Pier 33

Wilmington, North Carolina

RESPONSE TO SECOND SUBMISSION, EXTERIOR ELEVATIONS REVIEW COMMENTS

DATE: 5.29.2014
TO: Jeff Walton, Associate Planner
FROM: JDavis Architects, PLLC
PROJECT: Pier 33, Wilmington NC

NUTT STREET ELEVATION
SCALE: 1" = 30'-0"

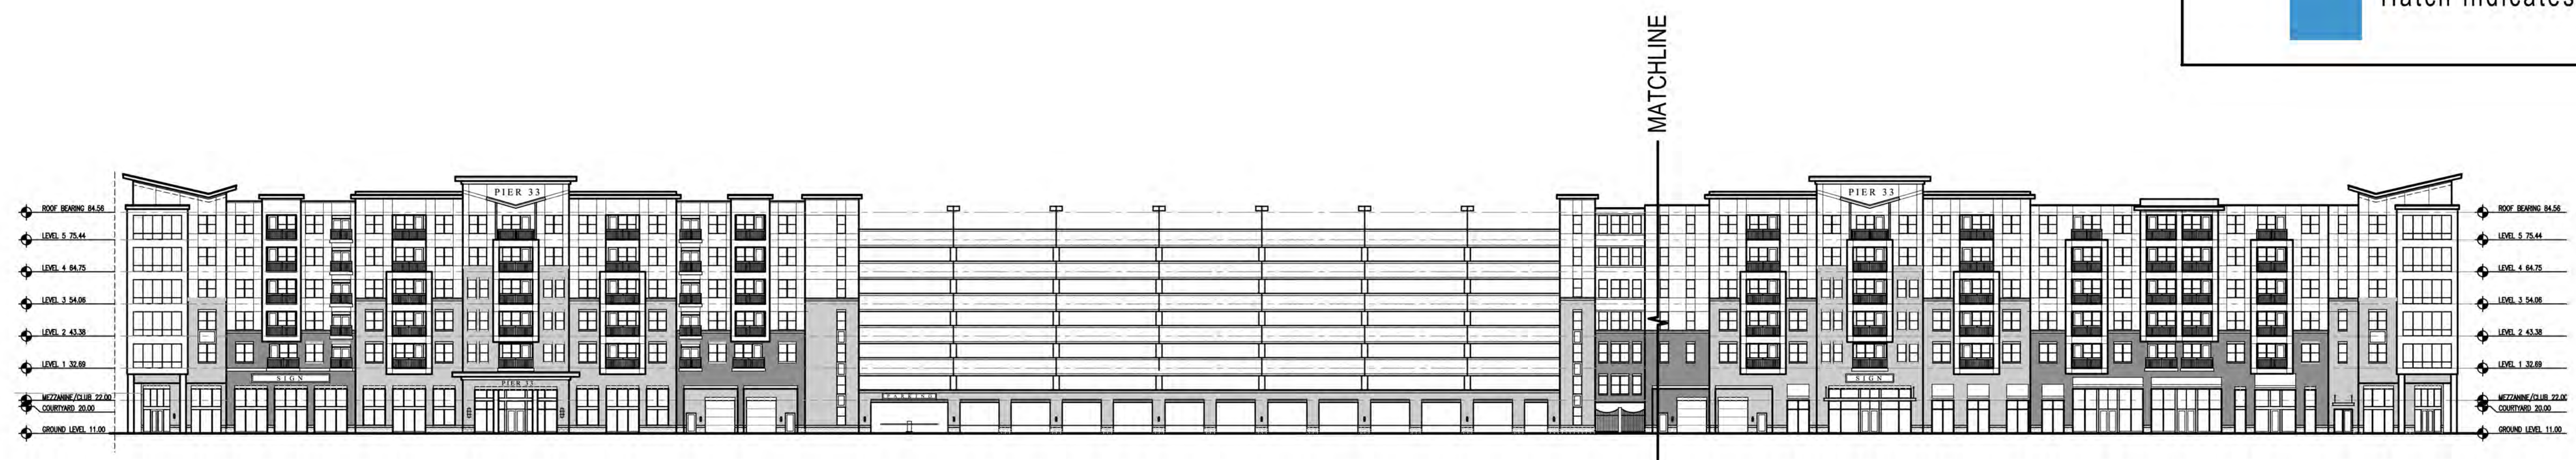
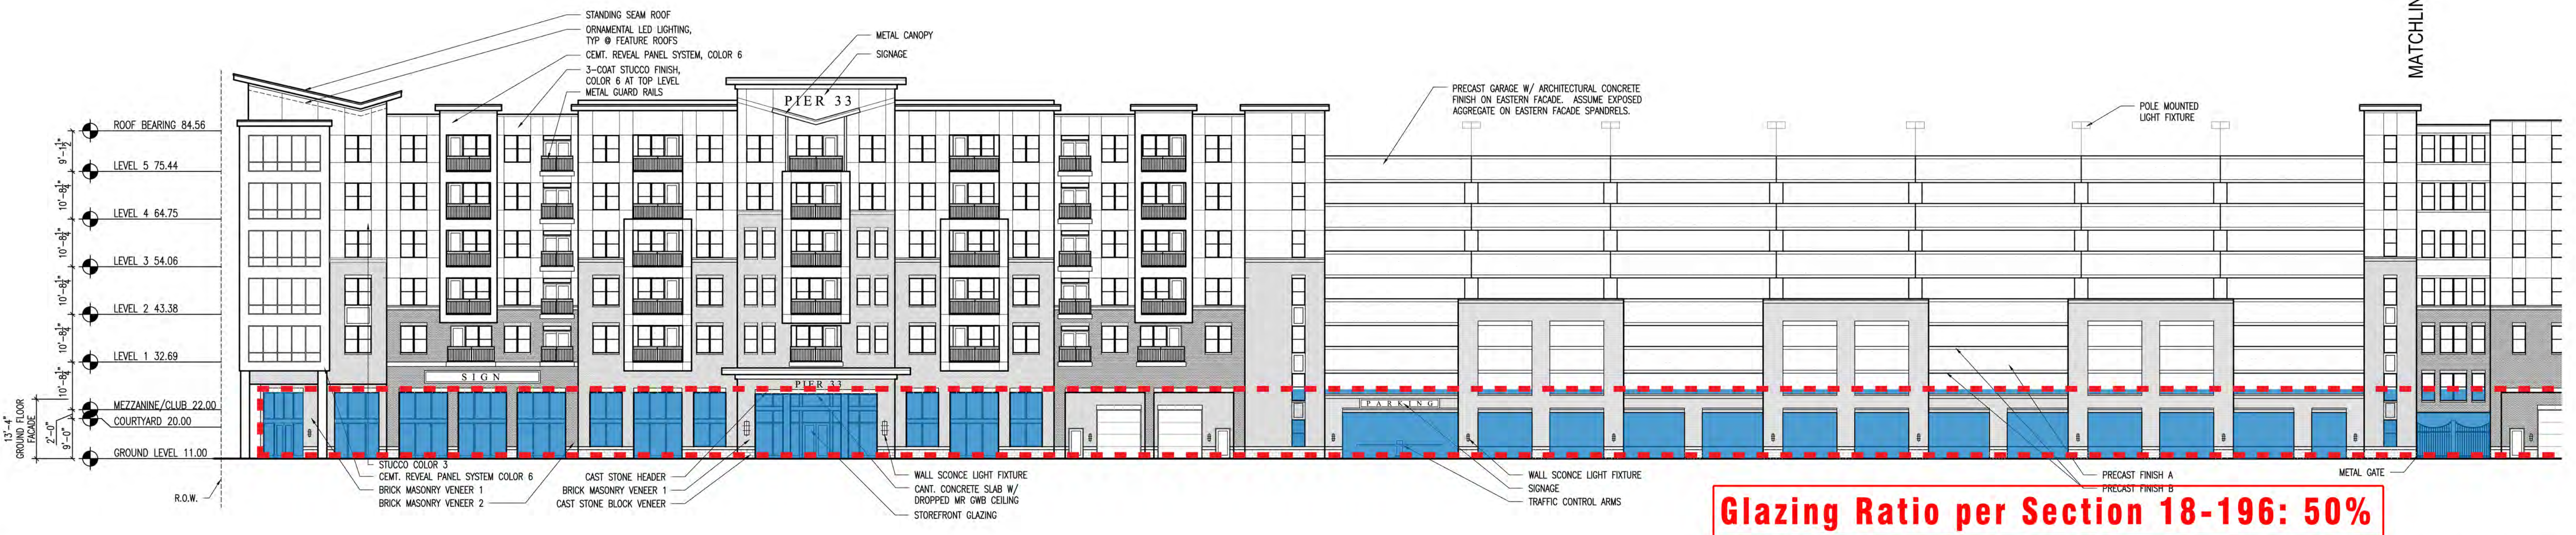
- I have concerns on the parking deck. You have a nicely designed project but I think the parking deck doesn't compliment your project. I have some ideas. I am in no way an architect just a low level planner but here we go.

- One idea I have is to take the columns within the structure and try to bring those vertical features to the façade to break up the façade visually. I will try to drawn my ideas on an attached redline.

- Another successful project was the CFCC parking deck. They took a black screen material to address verticality and I think it's a better product as a result. Will attach a Google image.

JDA Response: Attached see revised parking deck elevation. The brick veneer has been increase in height to the third parking level at three segments along the Nutt Street parking deck elevation. The locations with the increase brick height correspond with the structural precast concrete columns of the parking deck. The added three level brick elements and structural concrete columns serve as dominant vertical elements, break-up the mass of the parking deck elevation, and complement the rhythm of building elements along the entire Nutt Street elevation.

- Sec. 18-196 (c) (6): Street level facades. Buildings shall front onto public sidewalks to reinforce activity levels along public streets and pedestrian ways. Window glazing shall be the predominant material of the street-level facade.
 - o Label for compliance on the elevation sets along Nutt Street, Brunswick Street and the riverwalk.
 - I can buy your argument for Nutt Street. Show glazing for Brunswick Street as well. I need to work on the riverwalk. The elevated patios, I am not yet convinced on the glazing. I need to see the revised plan from Resnick for the final building footprint.

JDA Response: Glazing calculations were provided for Brunswick Street on 4/A3.01 – GLAZING CACULATIONS sheet included in the second submittal package. Glazing calculations have been included for Harnett Street. Comment acknowledged regarding glazing at Riverwalk. Coastal Site Design, PC to submit revised site plan with building footprint for evaluation.
